Access Compliance Report

Public Rights-of-Way

(Curb Ramps)

Intersection ID: 9824	Main Street: DINGLEWOOD_AV	Cross Street: TREMBETH_DR	Location: SE
ADA ID: 9C6345AF0538	Ramp Type: PerpDiag	Initial Pass/Fail: Fail	Overall Compliance: No
Codes/Mitigation Info/Possible Solution		Field Measurements/Component Compliance

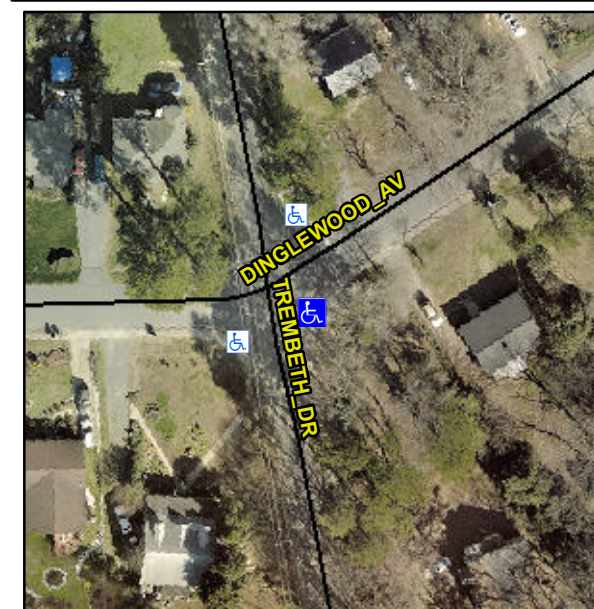
Not Found, R304.5.1, R304.2.2, R304.5.3

Compliance	Description	Data	Compliance	Description	Data
N/A	Ramp Length (in)	60.0	No	Ramp Slope (%)	9.3
No	Ramp Width (in)	47.0	No	Ramp XSlope (%)	4.5
N/A	Flare Type LT	N/A	N/A	Flare Type RT	N/A
N/A	Flare Slope LT (%)	N/A	N/A	Flare Slope RT (%)	N/A
N/A	Flare Traversable LT?	N/A	N/A	Flare Traversable RT?	N/A
N/A	Landing Length (in)	N/A	N/A	DWS Provided?	N/A
N/A	Landing Width (in)	N/A	N/A	DWS Contrast?	N/A
N/A	Landing Slope (%)	N/A	N/A	DWS Length (in)	N/A
N/A	Landing X Slope (%)	N/A	N/A	DWS Full Width?	N/A
N/A	Landing Curb? (Y/N)	N/A	N/A	DWS Offset (in)	N/A
N/A	Shared Landing?	N/A			
N/A	Gutter Ponding?	N/A	N/A	Gutter Slope (%)	N/A
N/A	Gutter Lip Ht (in)	0.75	N/A	Gutter X Slope (%)	N/A
N/A	Painted X Walk1?	No	N/A	Painted X Walk2?	No
	X Walk 1 Direction	To N		X Walk 2 Direction	To SW
N/A	X Walk 1 Width (in)	N/A	N/A	X Walk 2 Width (in)	N/A
	X Walk 1 Slope (%)	1.9		X Walk 2 Slope (%)	1.3
	X Walk 1 X Slope (%)	2.1		X Walk 2 X Slope (%)	2.3

Remove & Replace Curb Ramp With Two New Directional Ramps or Equivalent.
